ADDENDUM NO. 3

DATE: January 14, 2025
FROM: City of Grand Junction Purchasing Division
TO: All Offerors
RE: Crosby Avenue Utility Relocation IFB-5554-24-DD

CROSBY AVE UTILITY IMPROVEMENTS
IRRIGATION PLAN - 4
December 11, 2024

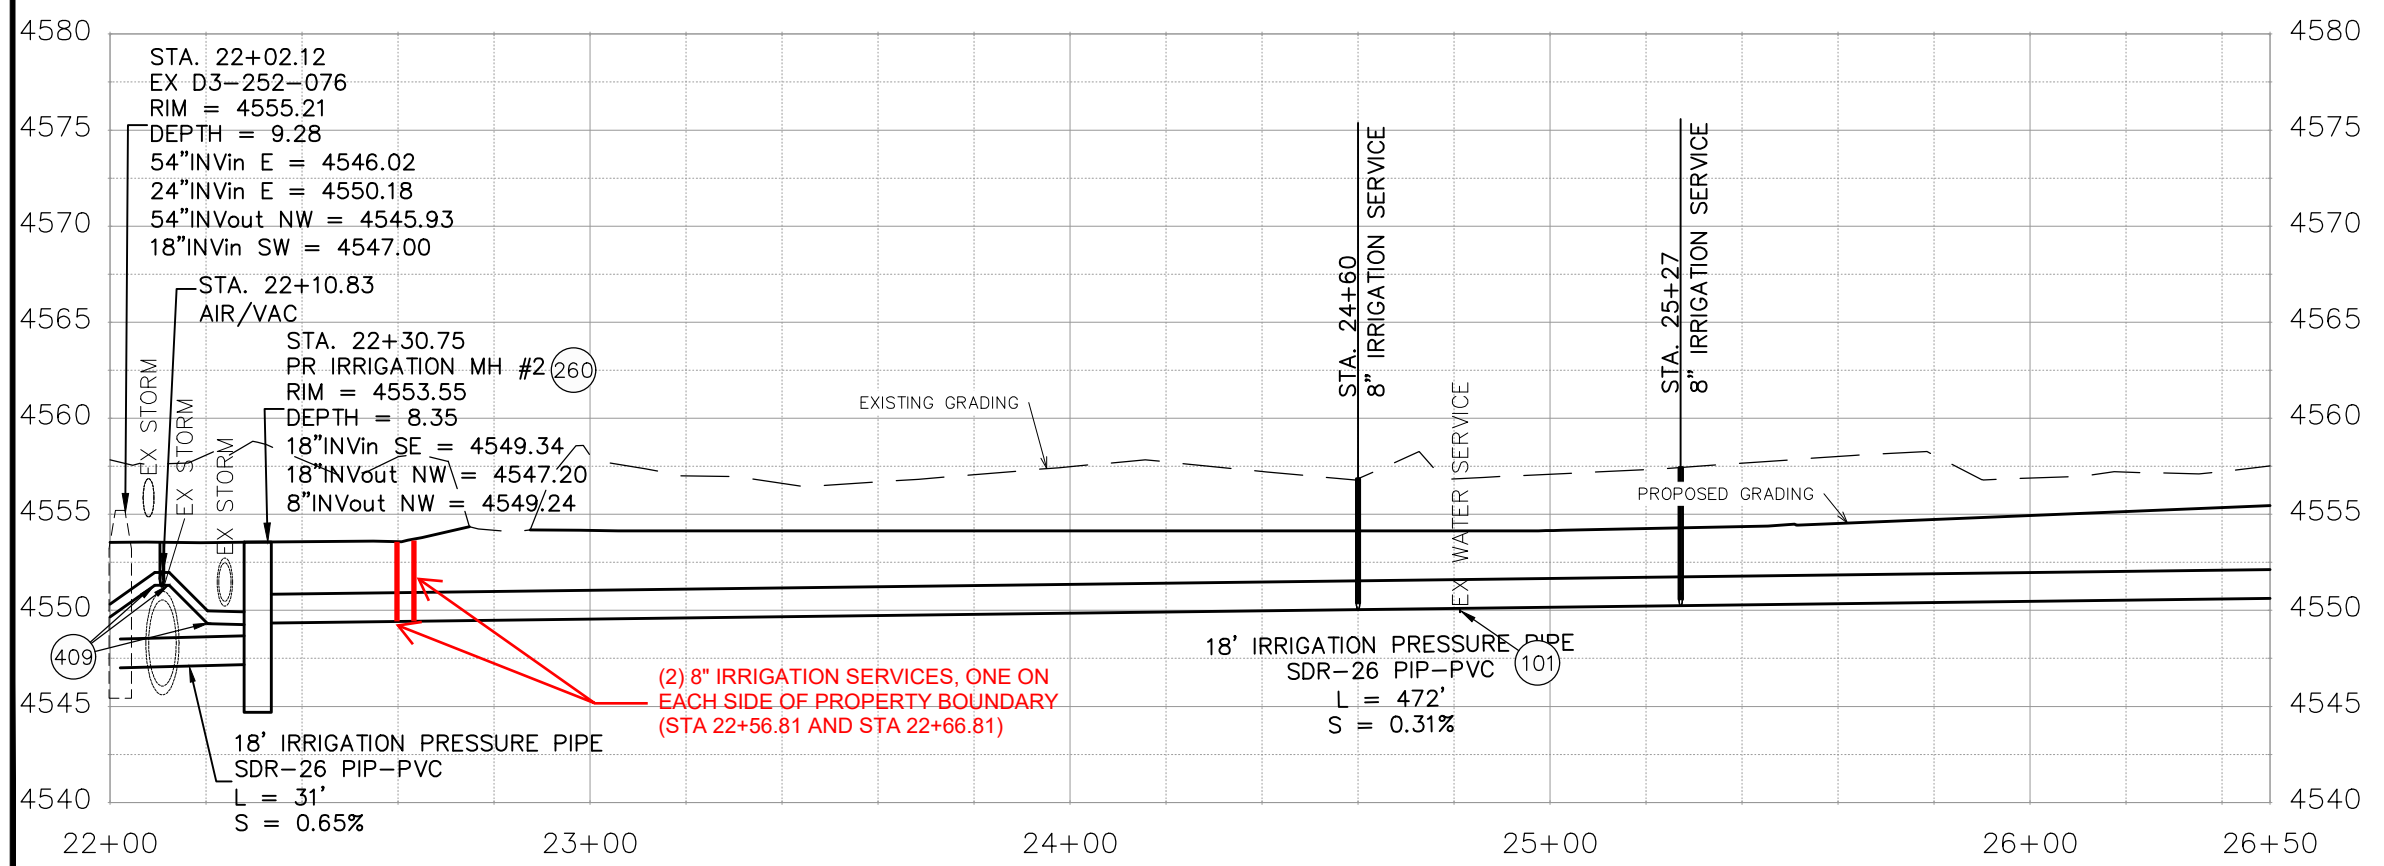
Answer: Back-to-back wyes will be acceptable. There are three on the 8" mainline on sheets 5-6.
16. **Clarification:** Two additional irrigation taps will be provided as indicated on the attached Sheet 4 of the Irrigation Plans.
